Alabama State Port Authority
APMT Phase IV Yard Expansion
ASPA Project 11261

Addendum #3

Date: May 30, 2024

WATER QUALITY UNIT DETAILS

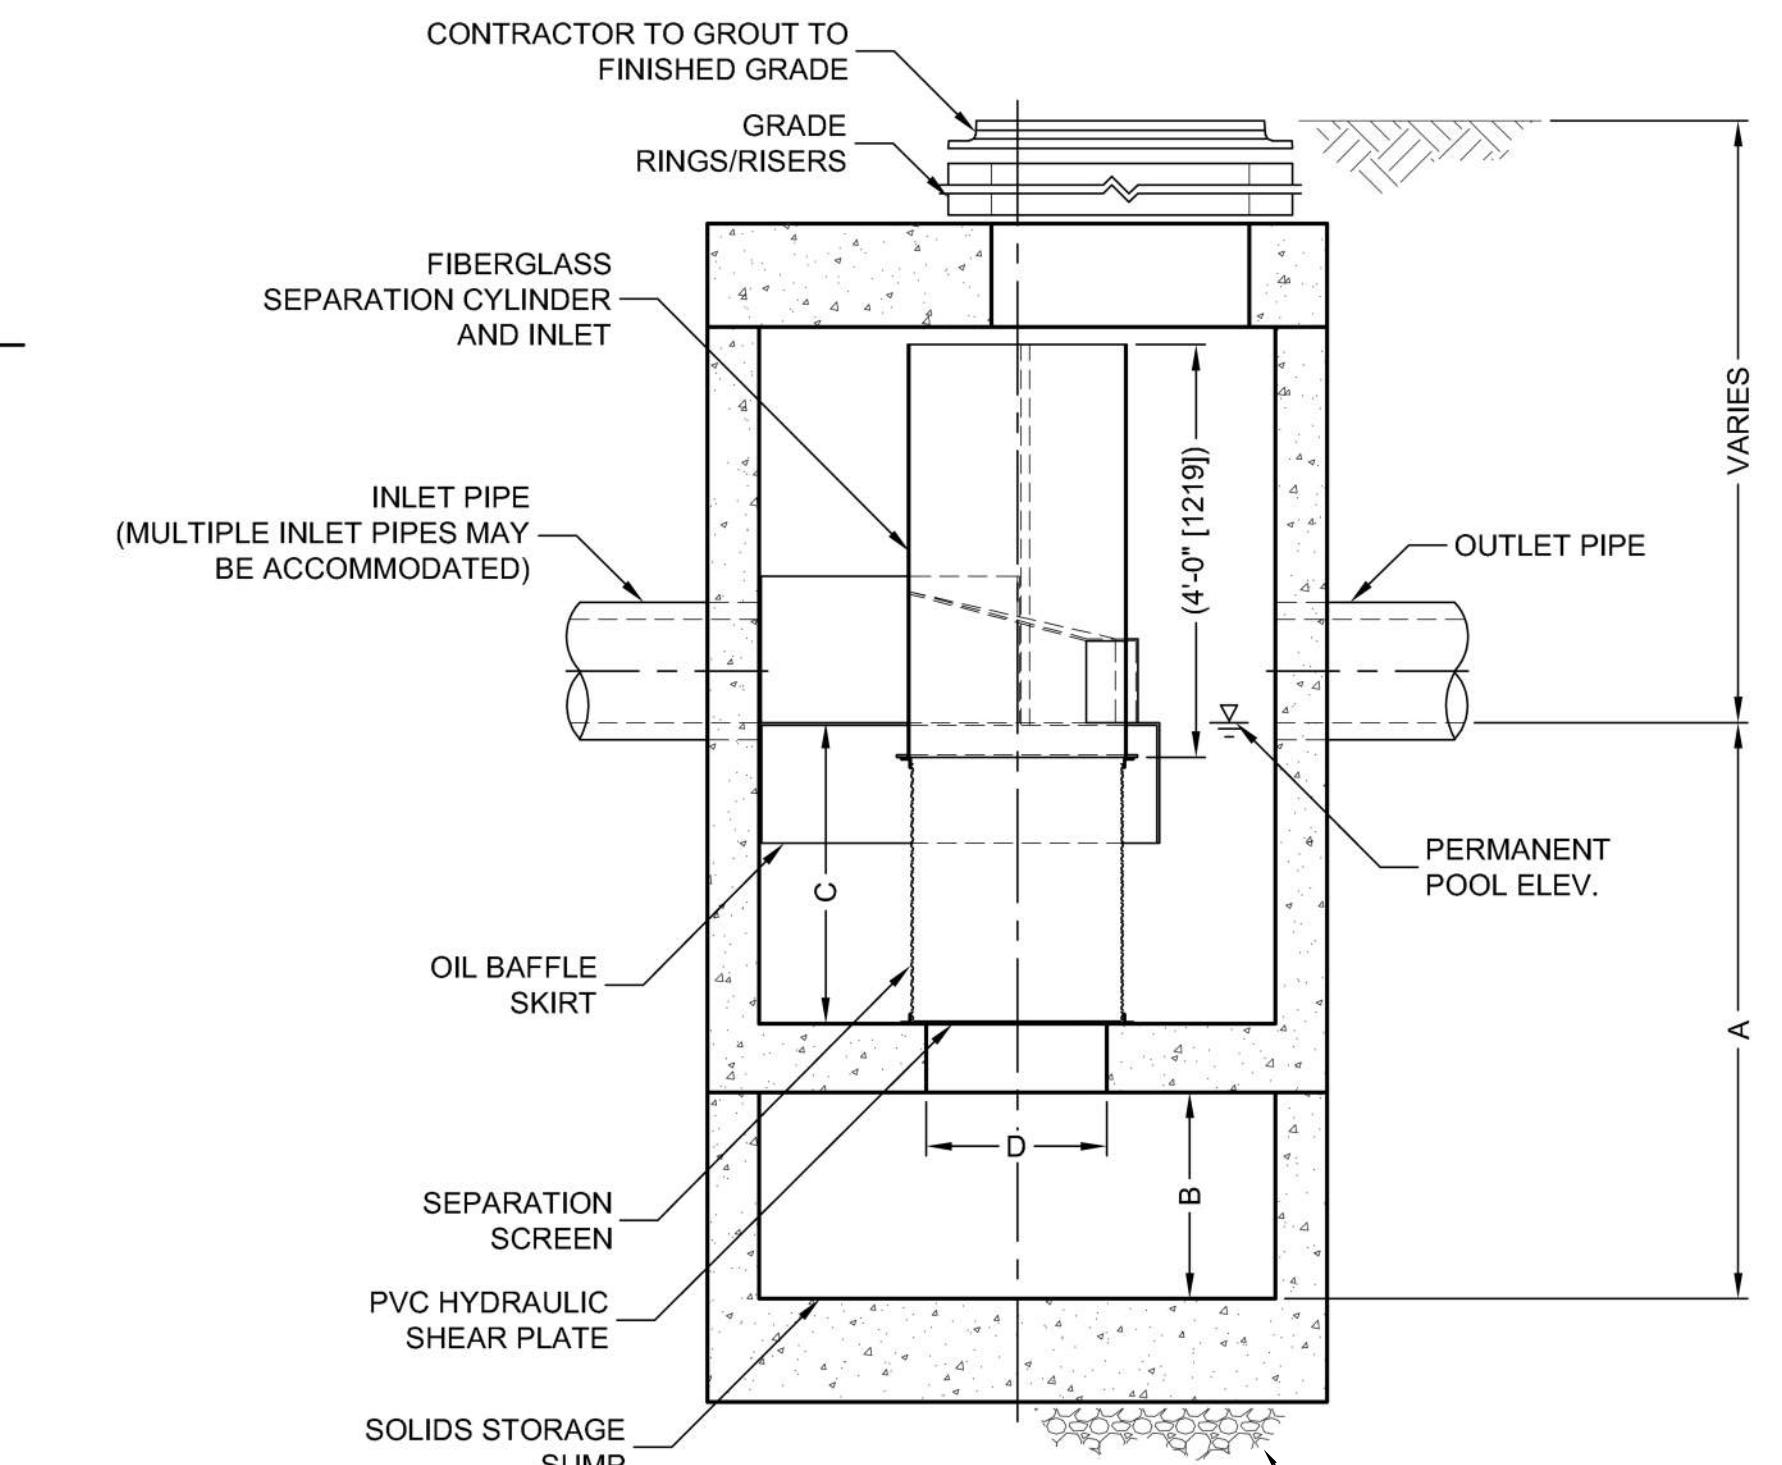
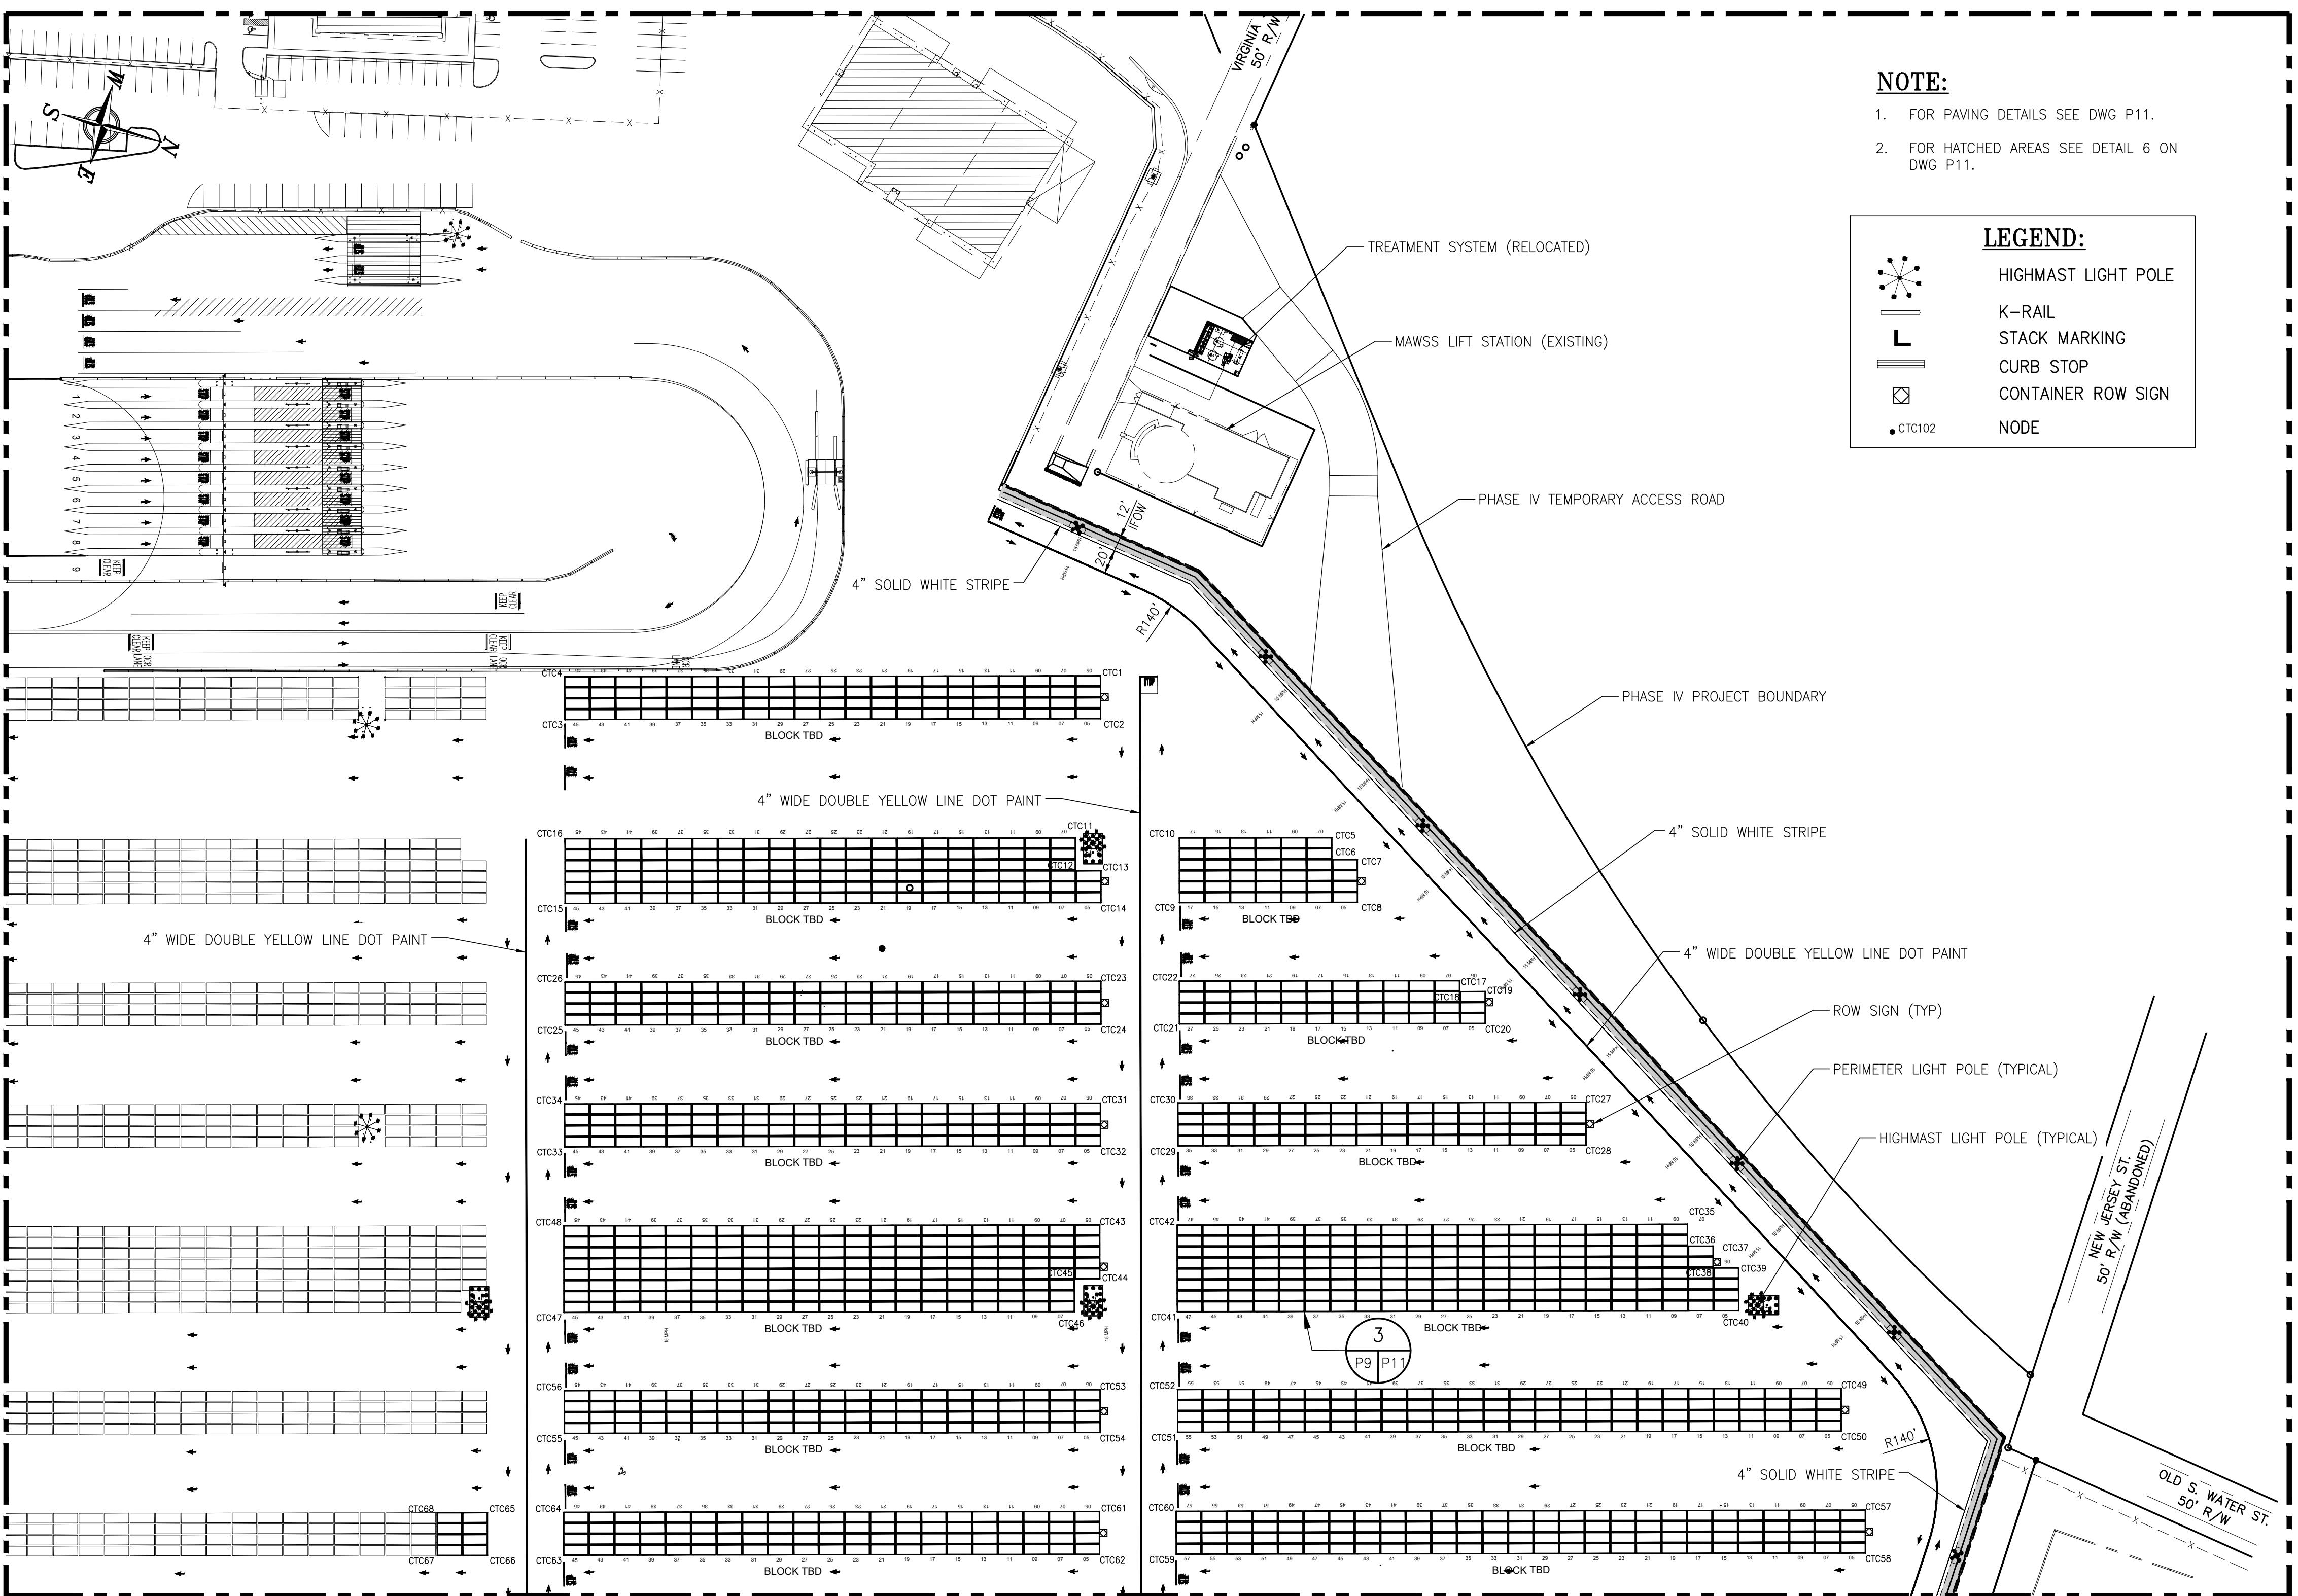
2.	DRAWING C26, Rev C – DRAINAGE STRUCTURE WATER QUALITY UNIT DETAILS , revised to reflect current water quality unit structures.
3.	DRAWING P9, Rev B – PAVEMENT MARKING – PARTIAL PLAN, SHEET 1 OF 2 , revised pavement markings along site perimeter

PARTIAL PLAN - (SHEET 2 OF 2)

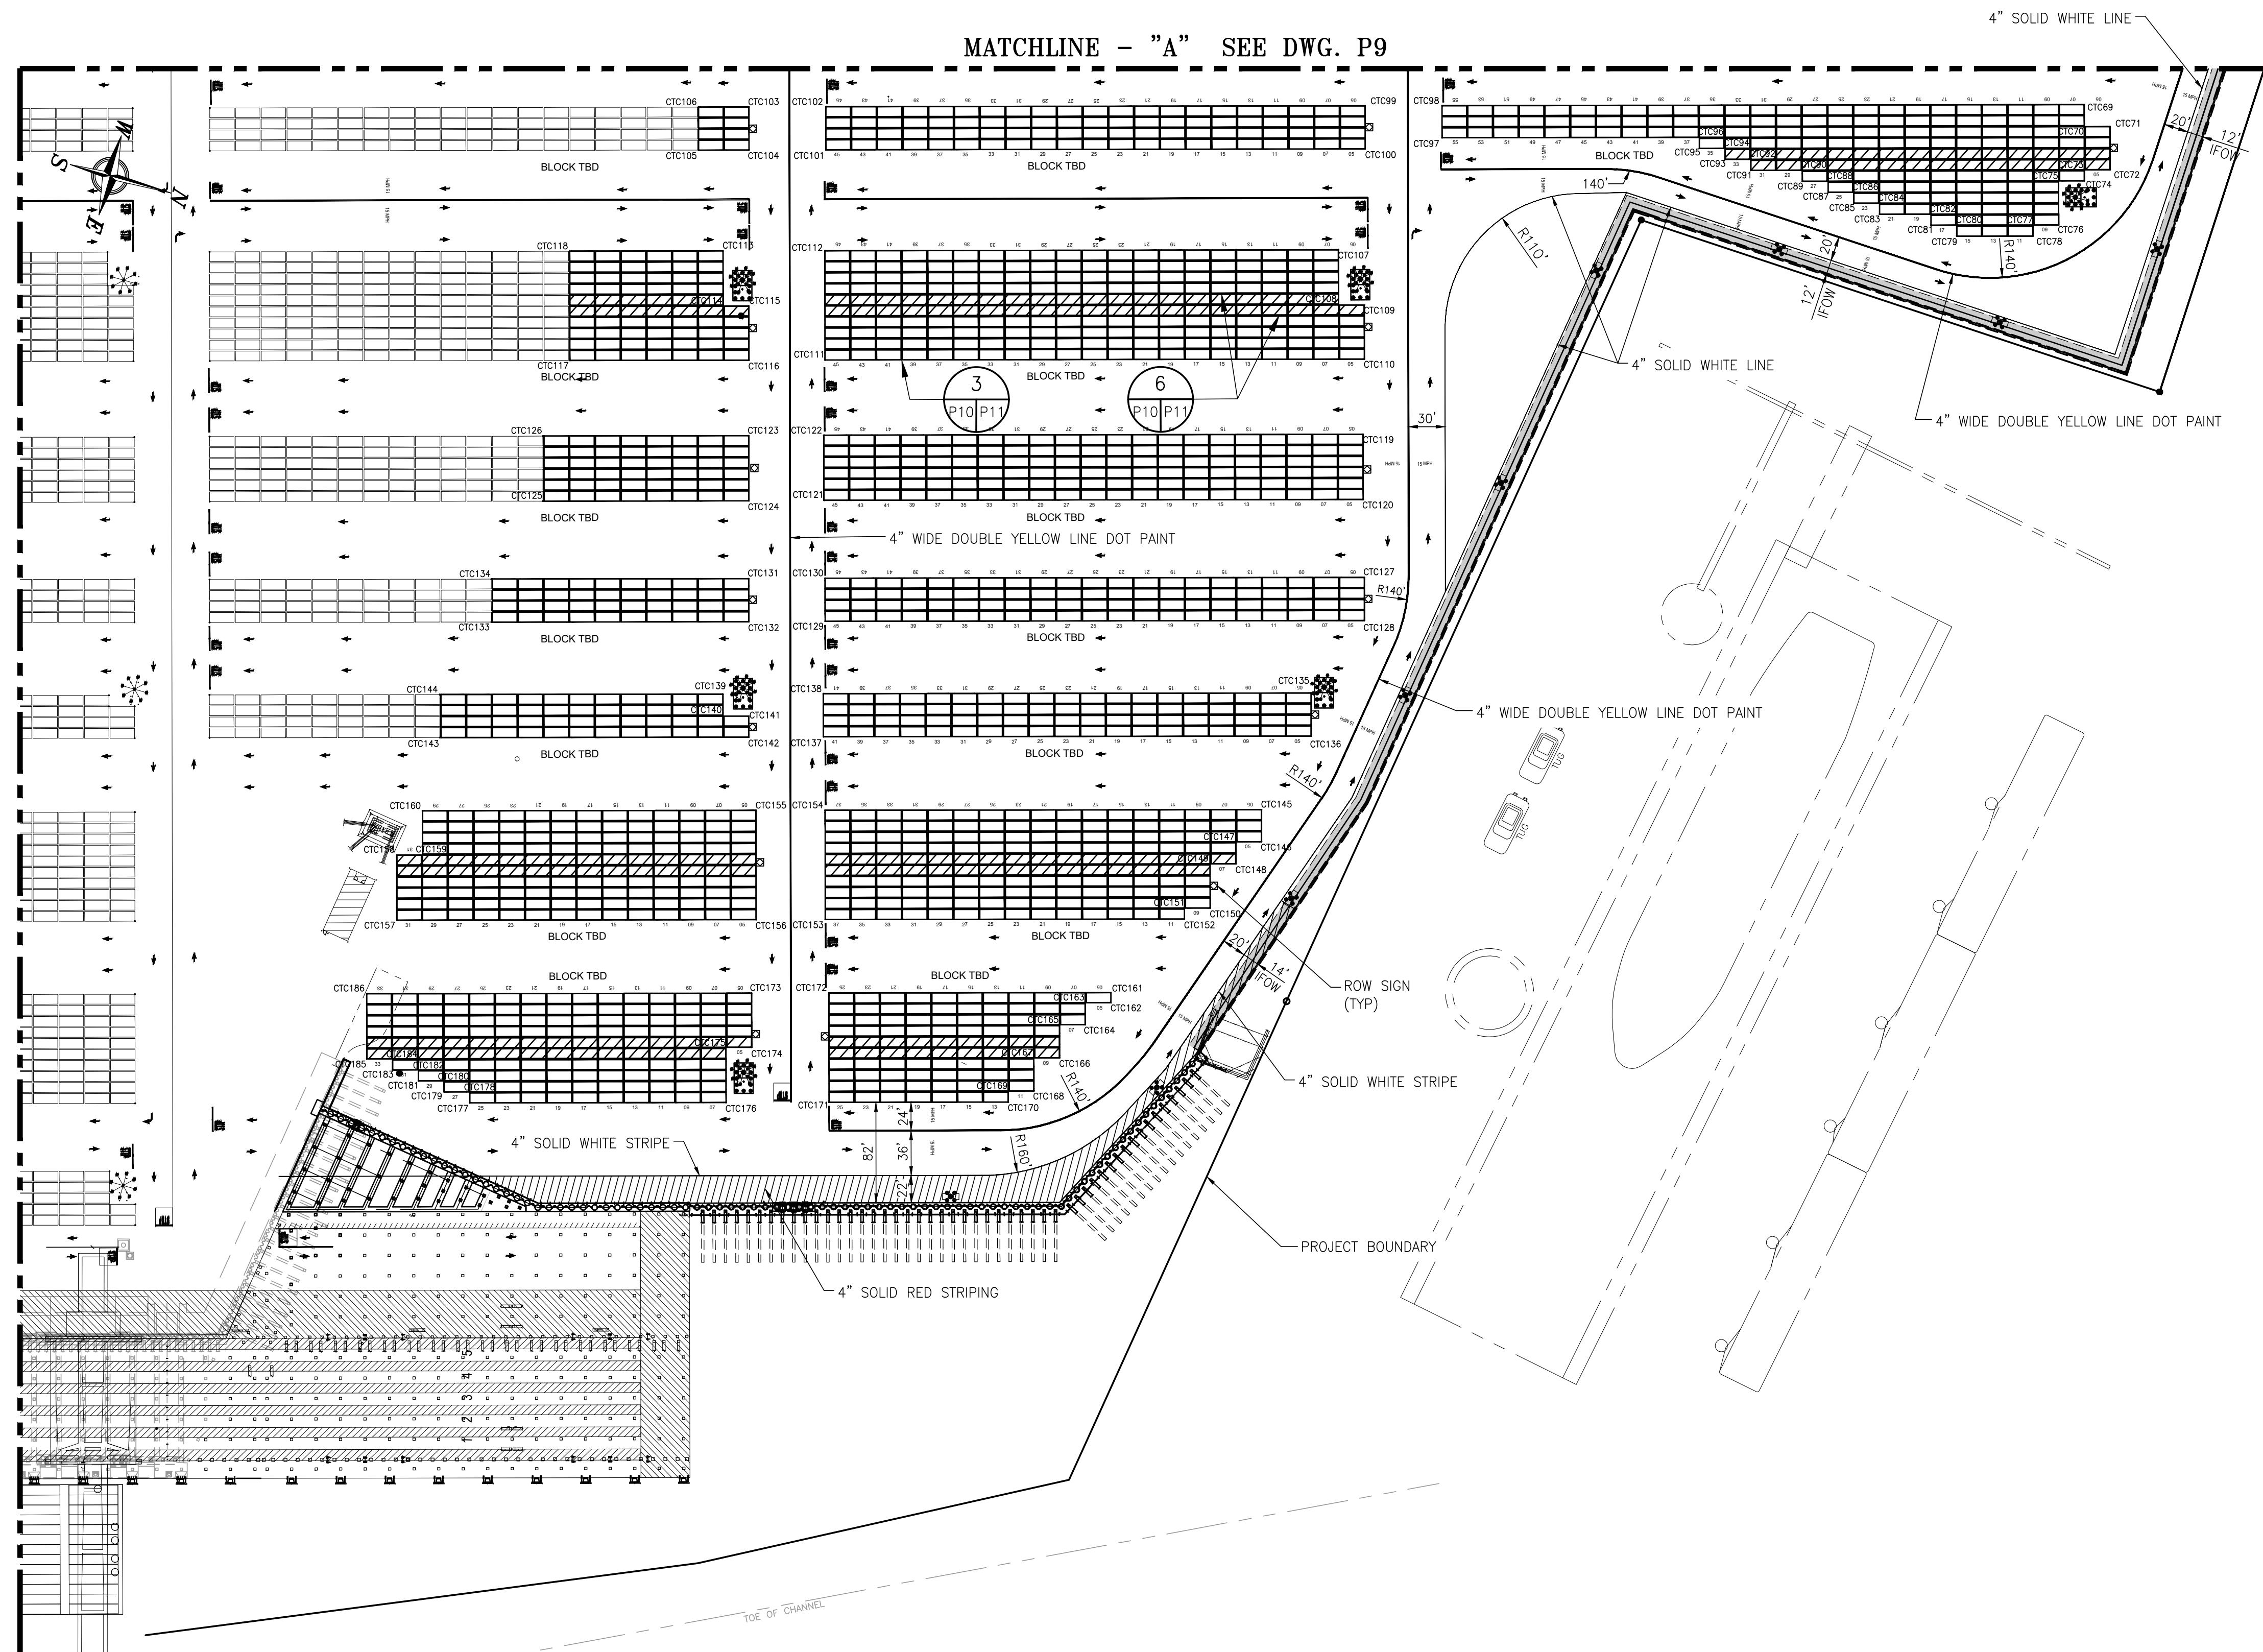
4.	DRAWING P10, Rev B – PAVEMENT MARKING – PARTIAL PLAN, SHEET 2 OF 2 , revised pavement markings along site perimeter
QUESTIONS	
5.	Due to the approximate 3-year duration of the project, will there be any consideration for price escalation? Answer: No.

56.	<p>On plan sheet P10, is the hatched container striping pattern (diagonal pattern) meant to represent the 4" White D.O.T Paint referenced on detail 6 on P11?</p> <p>Answer: See attached drawings P9 and P10.</p>

DESIGN LOADS:

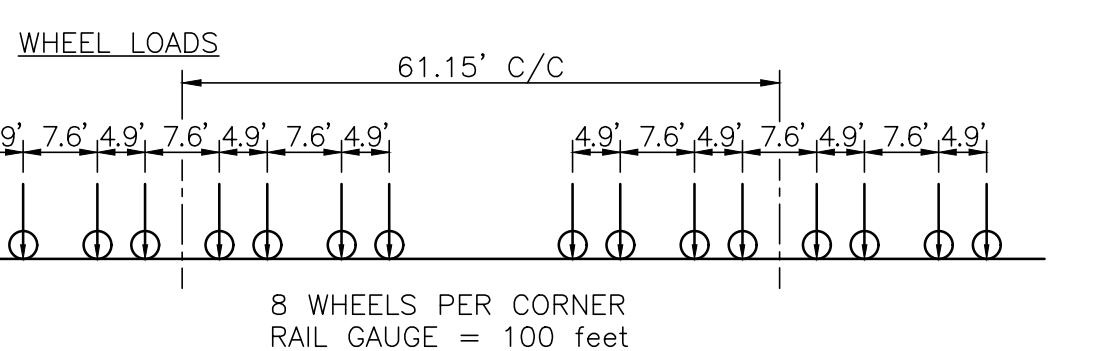
20.	Are there any load restrictions on the existing dock? Please clarify. Answer: Please see attached drawing 4111-S1 for dock allowable loading.
